BOARD ACTION REPORT – APPEALABLE ITEM

Project Name:	115 North Dixie Boulevard
Project Location:	115 North Dixie Boulevard, Del-Ida Park Historic District
Request:	Certificate of Appropriateness
Board:	Historic Preservation Board
Meeting Date:	July 18, 2018

HISTORIC PRESERVATION BOARD CITY OF DELRAY BEACH STAFF REPORT

115 North Dixie Boulevard, Del-Ida Park Historic District – Certificate of Appropriateness (2018-100) for construction of a new 1-story, courtyard style single-family residence with an attached 2-car garage on an existing vacant lot.

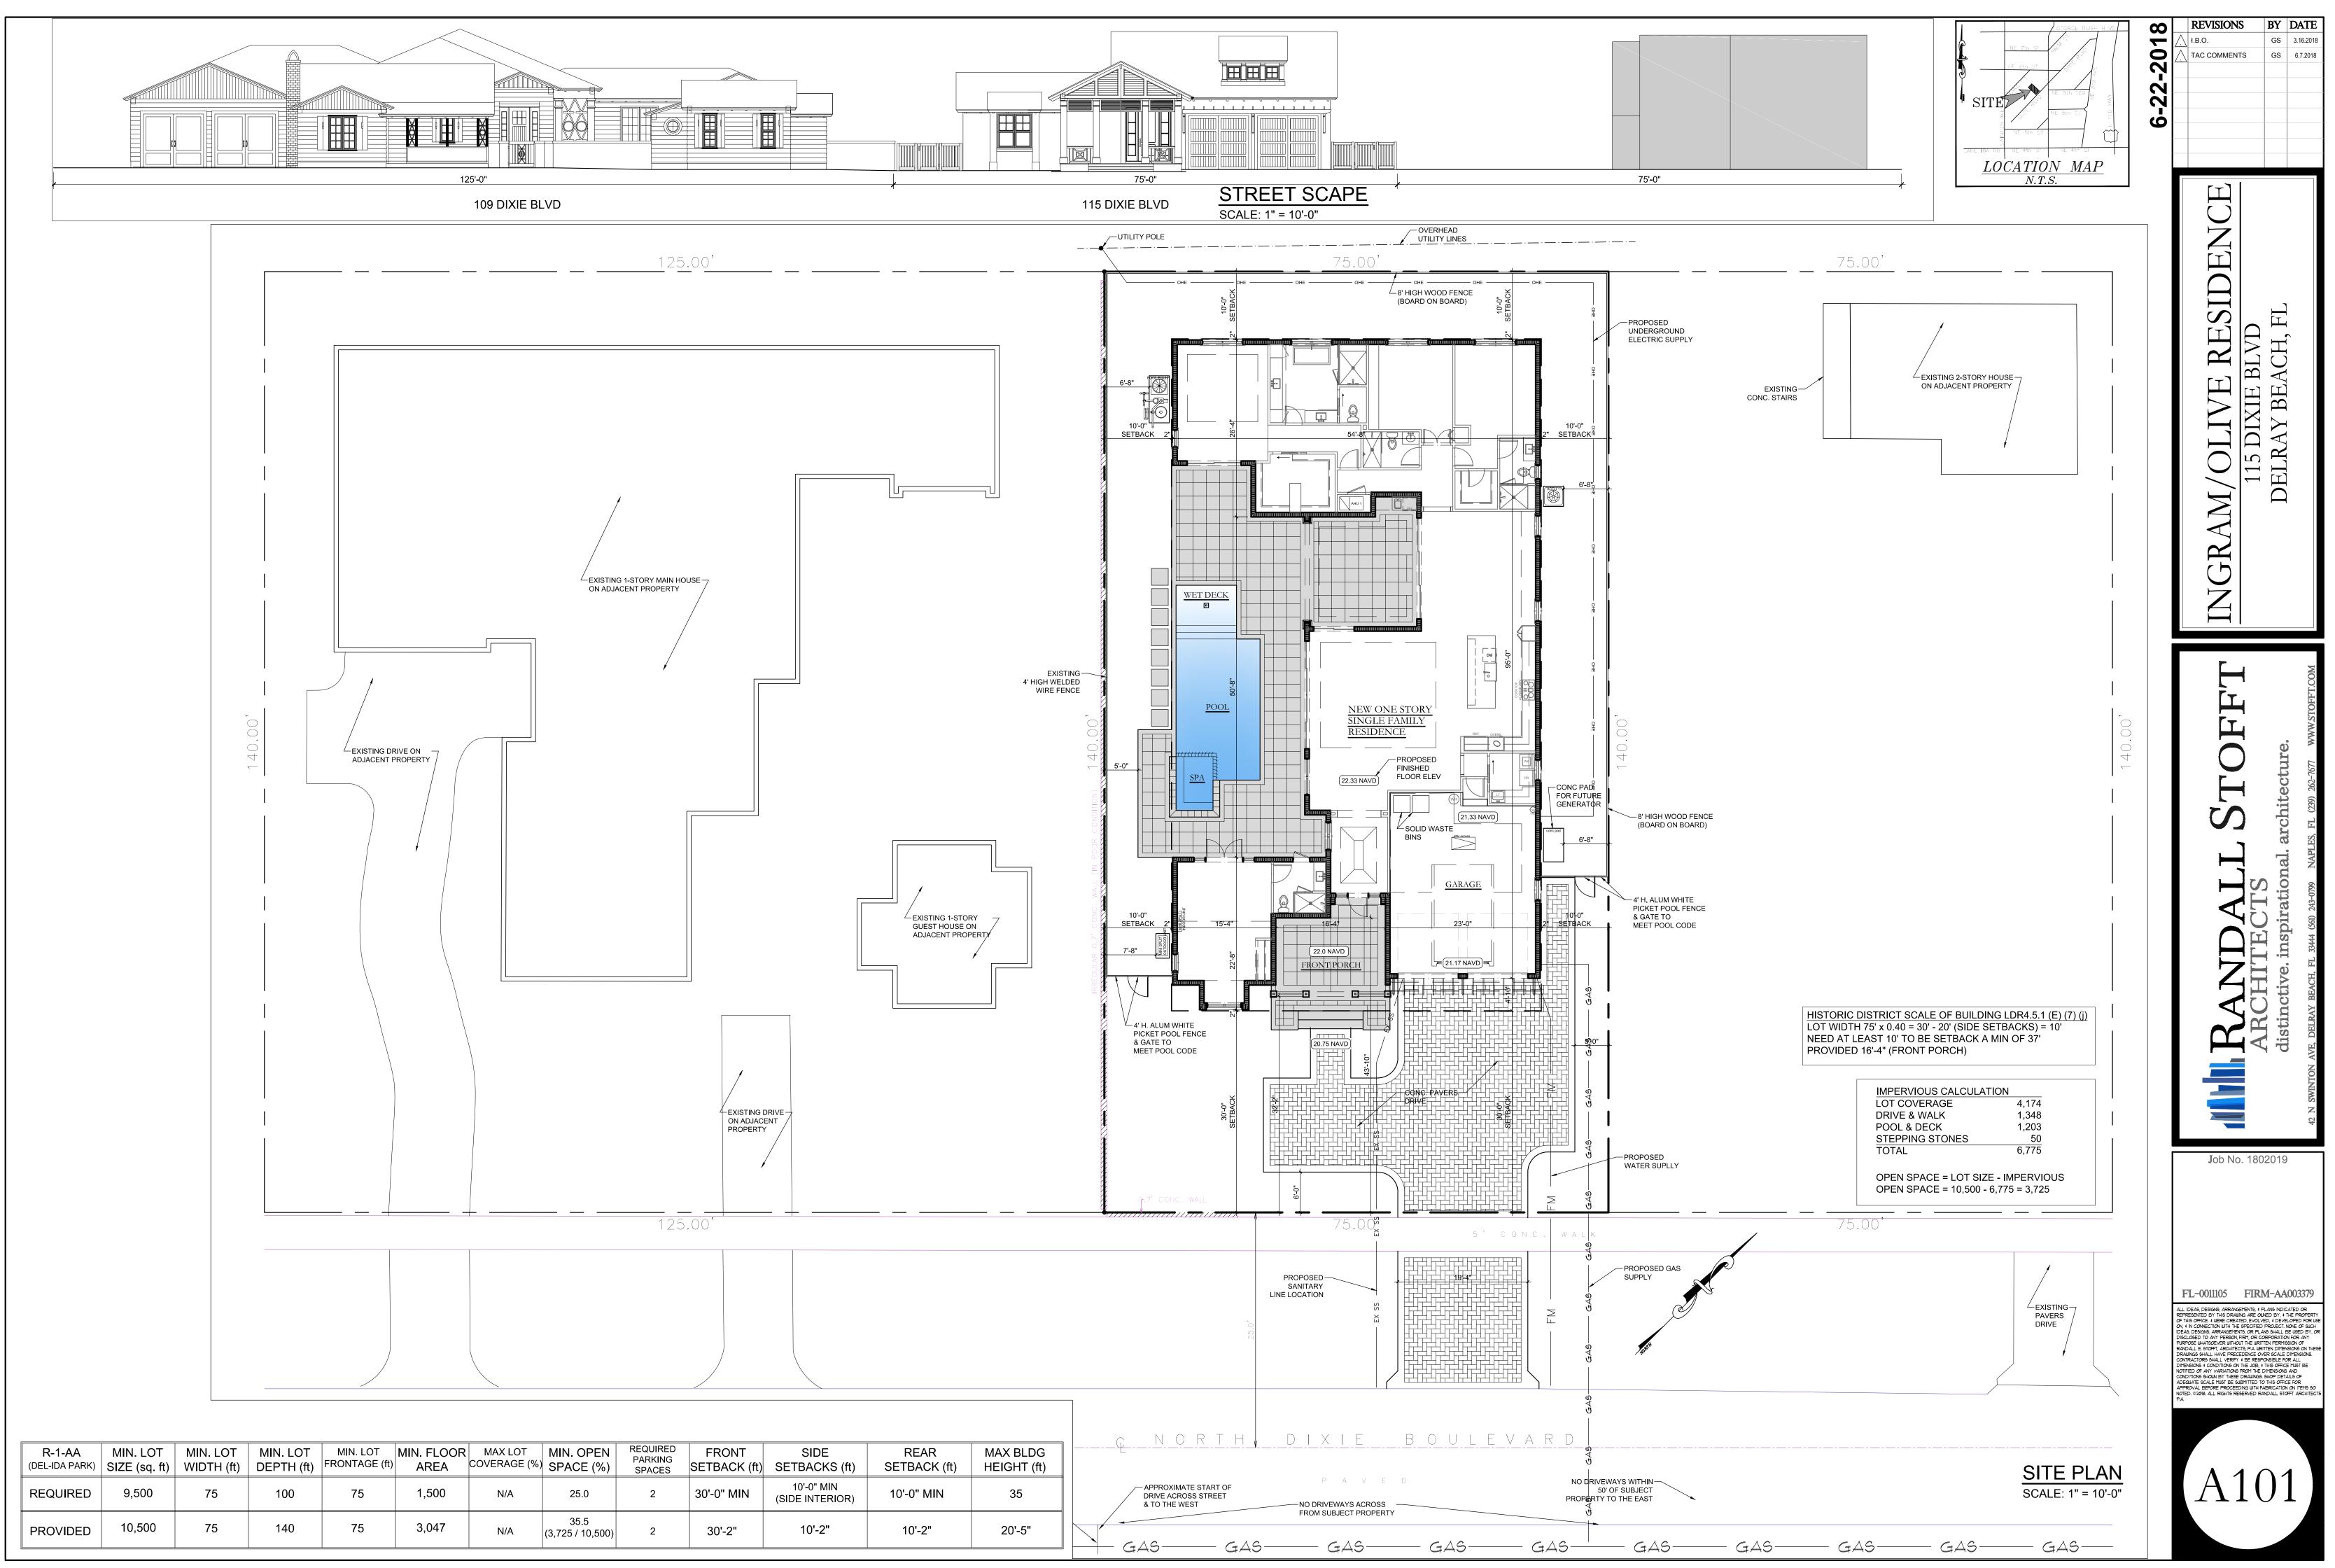
- 1. That the location of driveways and/or access points of adjacent properties within 50 feet, including intersections across North Dixie Boulevard, be illustrated (sheet A101).
- 2. That a note be added indicating the material and color of the exterior light fixtures (sheet A301).
- 3. That note 210 on the 200 Series Keynotes chart be removed (sheet A201).
